MAINE TURNPIKE AUTHORITY

ADDENDUM NO. 4

CONTRACT 2025.11

AUBURN VEHICLE STORAGE GARAGE

SHEET NUMBER: ES100																															
		32 OF 36

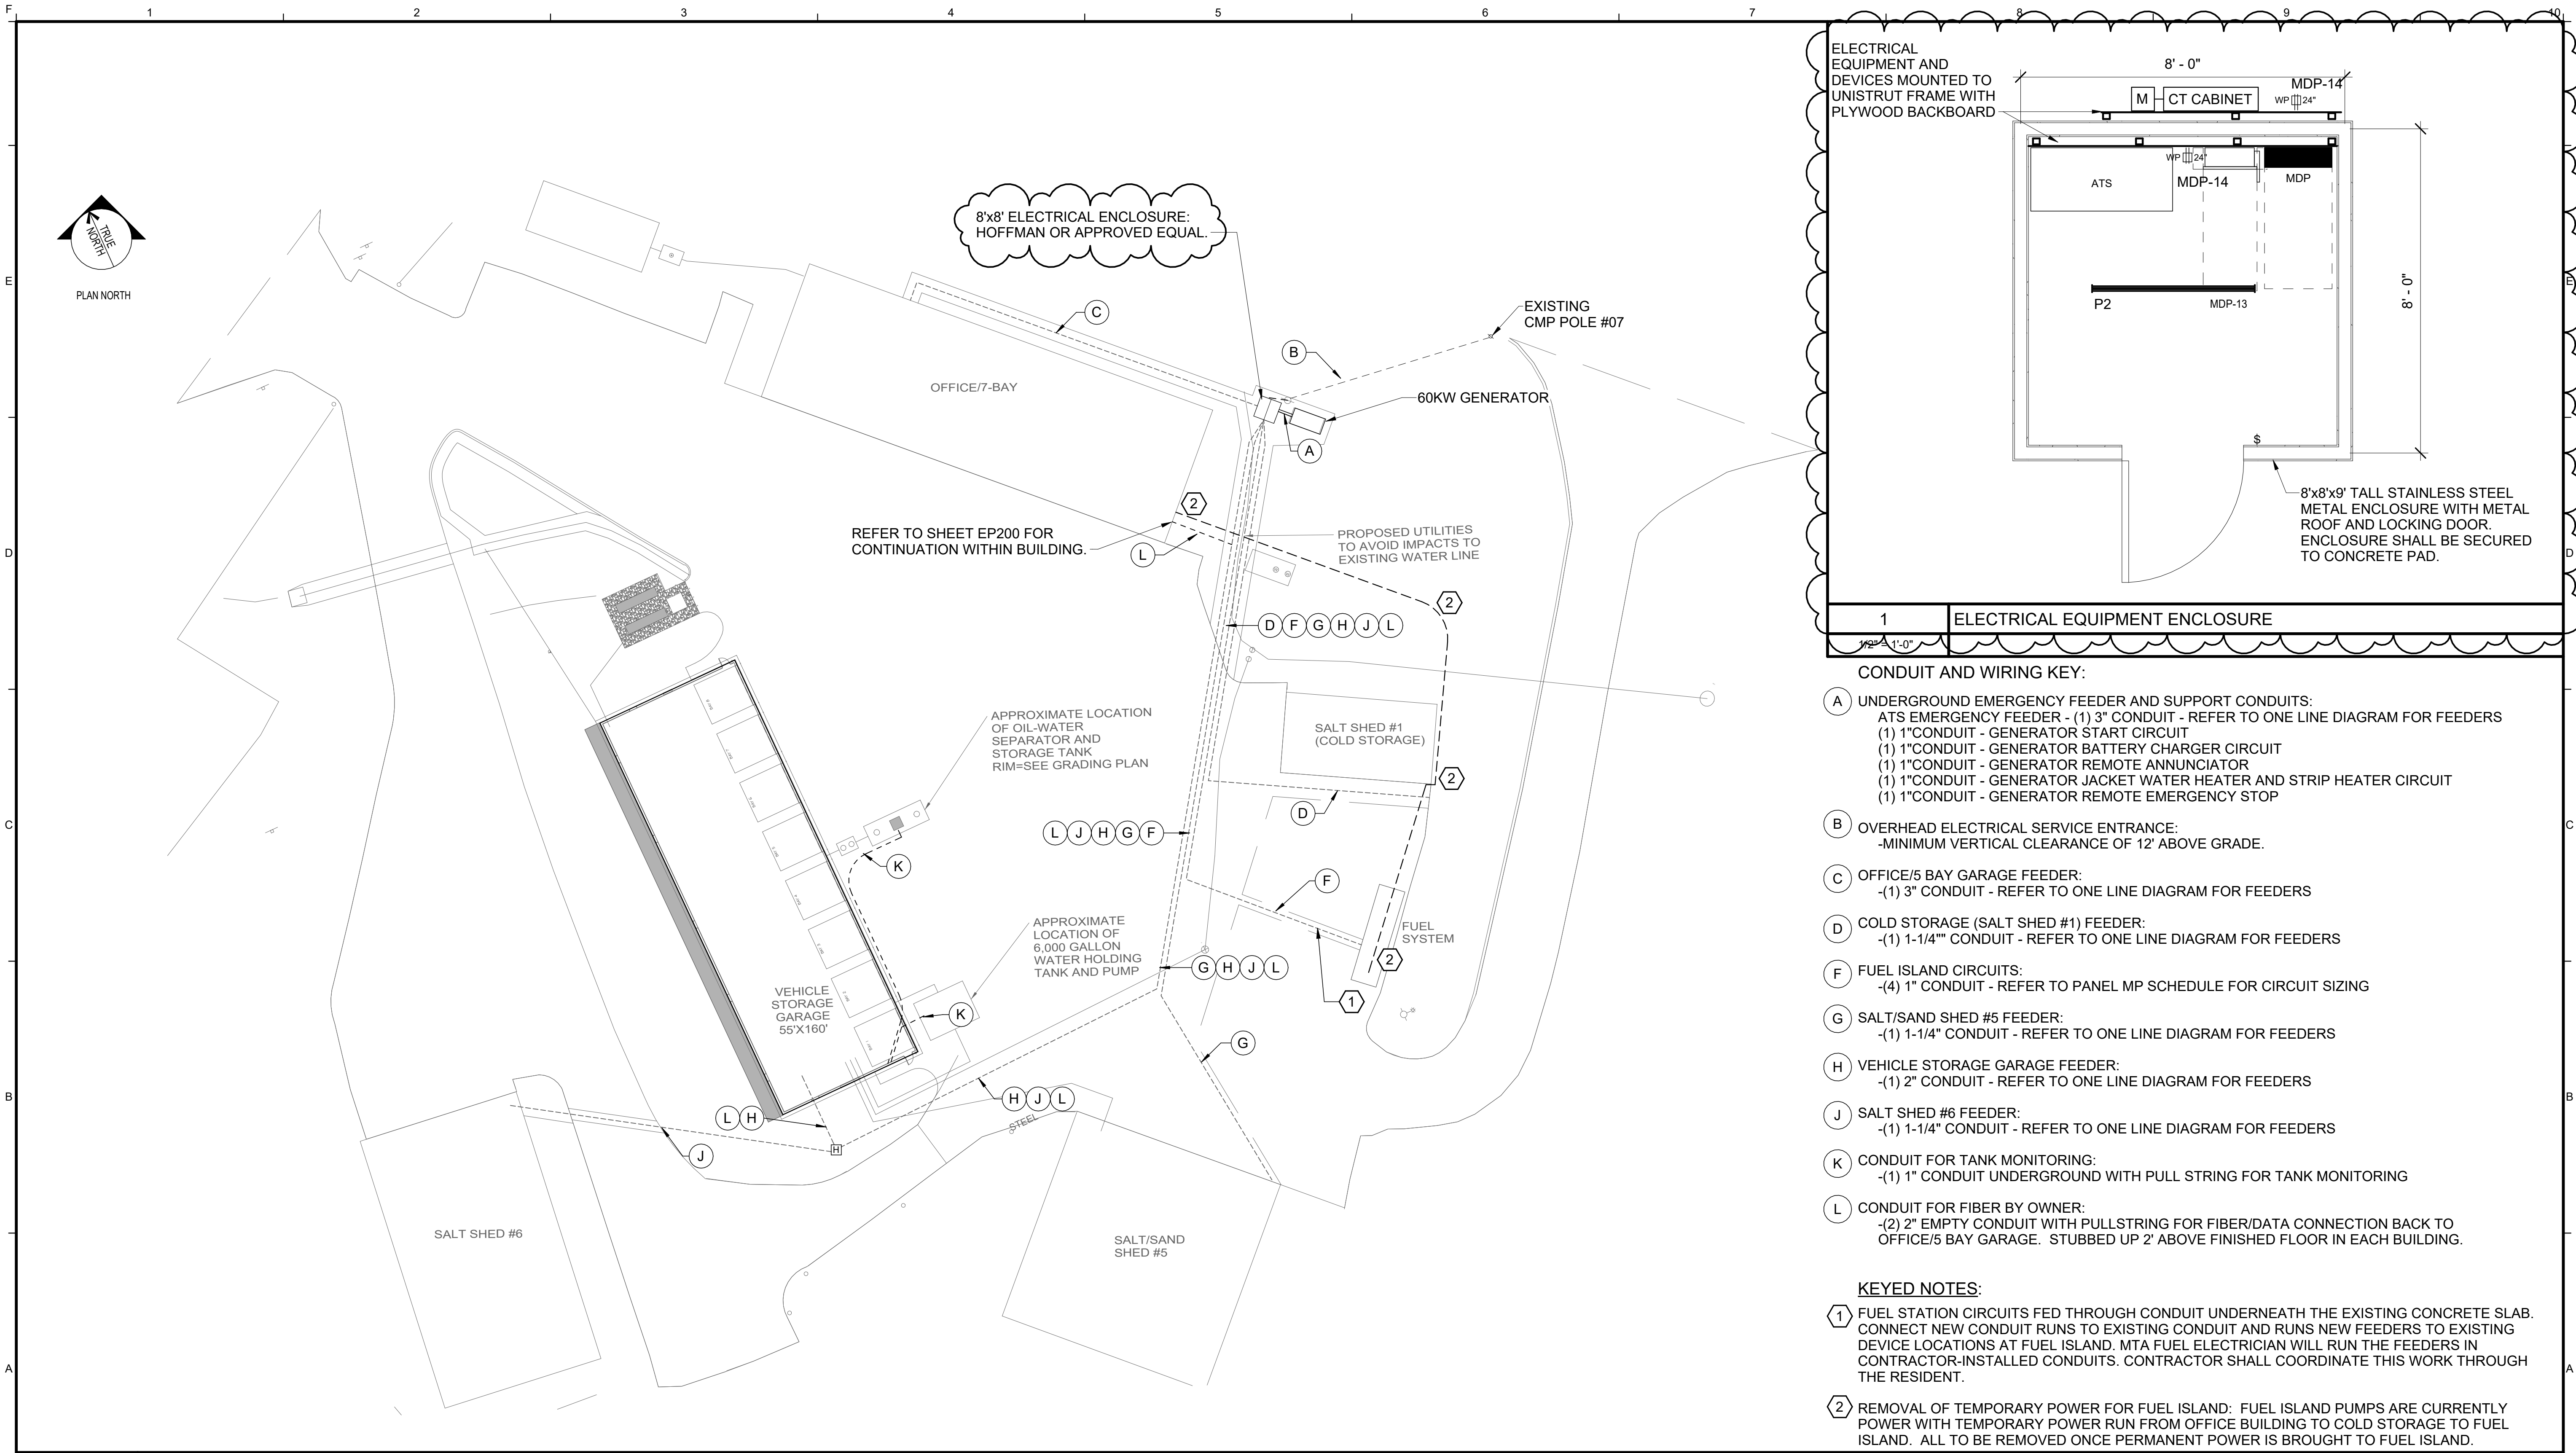
1. Plan sheet 20 of 36 – Details (Revised): Contractor shall make a 'pen and ink' change by deleting the words "Liner Panel" from Details 9 thru 15, and adding in its place, "Metal Closure Trim".
2. Plan sheet 32 of 36 – Electrical Site Plan: Contractor shall delete Sheet 32 of 36 – Electrical Site Plan and replace with Sheet 32 of 36 – Electrical Site Plan, with Revision Block noting Addendum #4 and dated 6/12/2025. The revised sheet provides clarification to the Electrical Equipment Enclosure and additional details for enclosed electrical equipment.
3. Plan sheet 33 of 36 – Lighting Plan: Contractor shall delete Sheet 33 of 36 – Lighting Plan and replace with Sheet 33 of 36 – Lighting Plan, with Revision Block noting Addendum #4 and dated 6/12/2025. The revised sheet provides additional information for the Electrical Equipment Enclosure lighting.

Question 4: Please advise if there is a contact for the 8x8x8 metal building shown on the electrical drawings ES100 page 32. At this time, Hoffman does not have this size, and none of the local metal builders will build this.

Answer: This is not intended to be a building. It is a simple electrical equipment enclosure. The intent is an 8’x8’x9’ tall stainless steel metal, enclosure with metal roof. The enclosure shall be secured to the concrete pad. If Hoffman does not offer the size requested, alternate manufacturers or alternate sizes will be considered. Revised electrical drawings included with this addendum are offered to clarify the design intent. Note that all panels/meters shall be mounted to Unistrut and that the Unistrut is free standing and not mounted to the enclosure. All electrical panels/ats/equipment shall be Nema 3R.

A1		POWER RISER DIAGRAM	
NONE			
Scale:		Designed by:	
12" = 1'-0"		Anthony S. Davis, PE	
No.	Revision	By	Date
1	Addendum #3	SO	05/16/2025
2	Addendum #4	SO	06/12/2025
		By	Date
Designed:		BTG	04/25/2025
Checked:		BTG	04/25/2025
Drawn:		PMC	04/25/2025
		By	Date
		BTG	04/25/2025

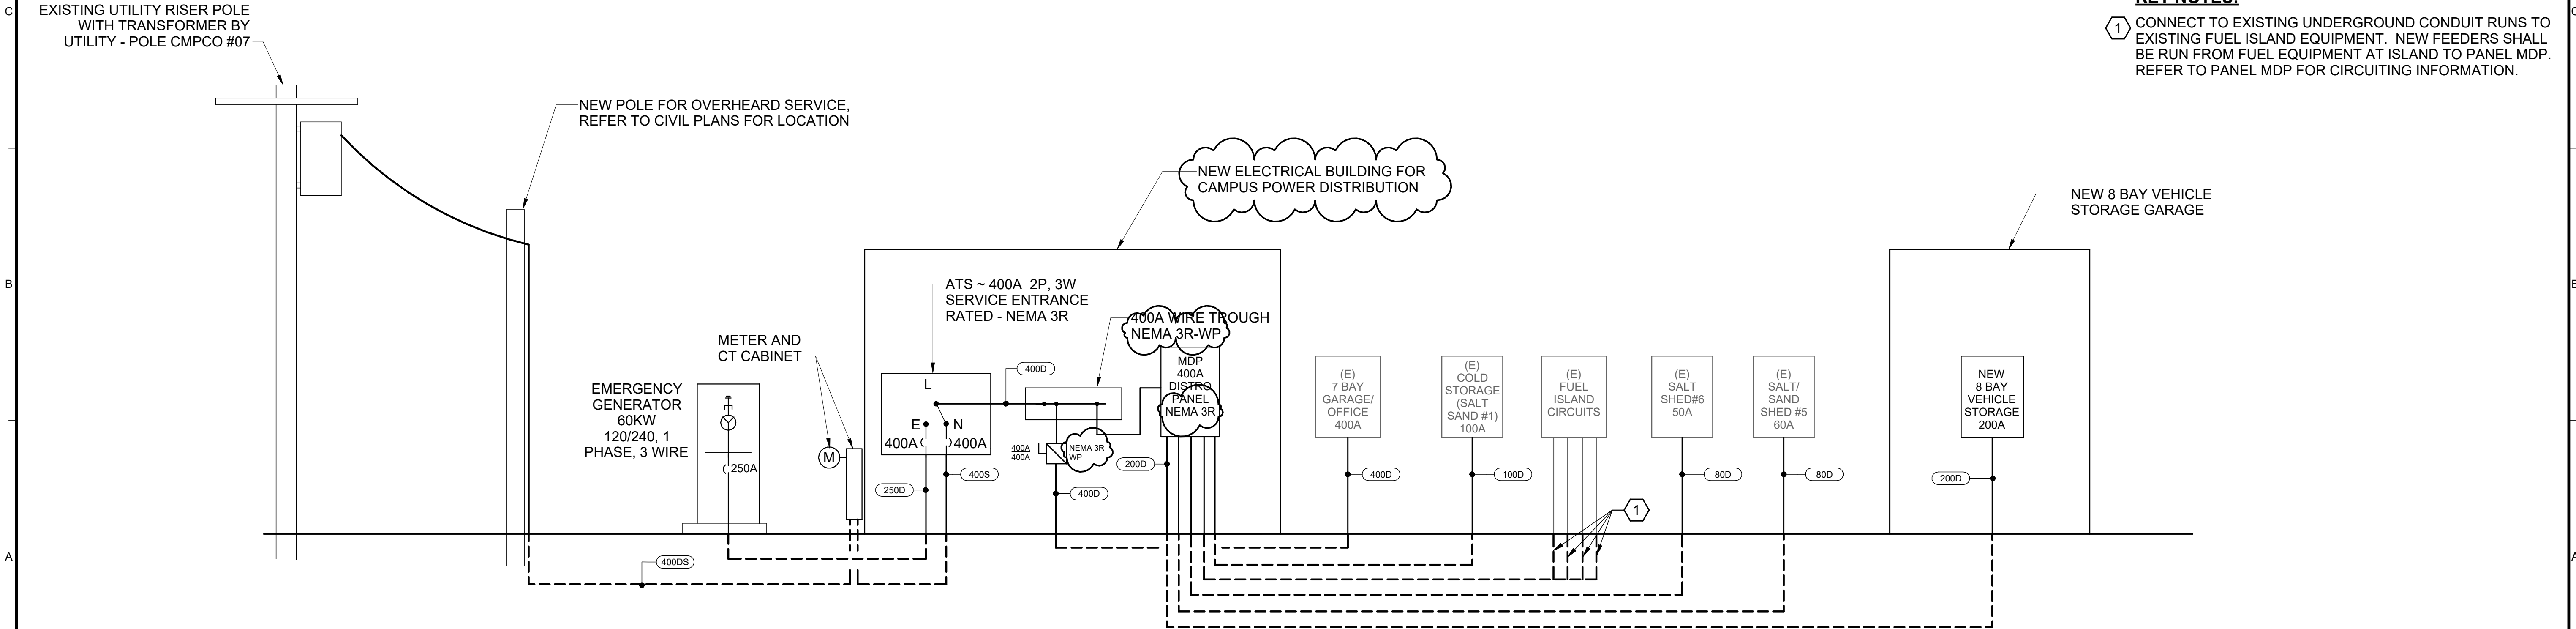
4. Plan sheet 36 of 36 – Power Riser Diagram: Contractor shall delete Sheet 36 of 36 – Power Riser Diagram and replace with Sheet 36 of 36 – Power Riser Diagram, with Revision Block noting Addendum #4 and dated 6/12/2025. The revised sheet provides clarification to the electrical equipment within the electrical equipment enclosure.
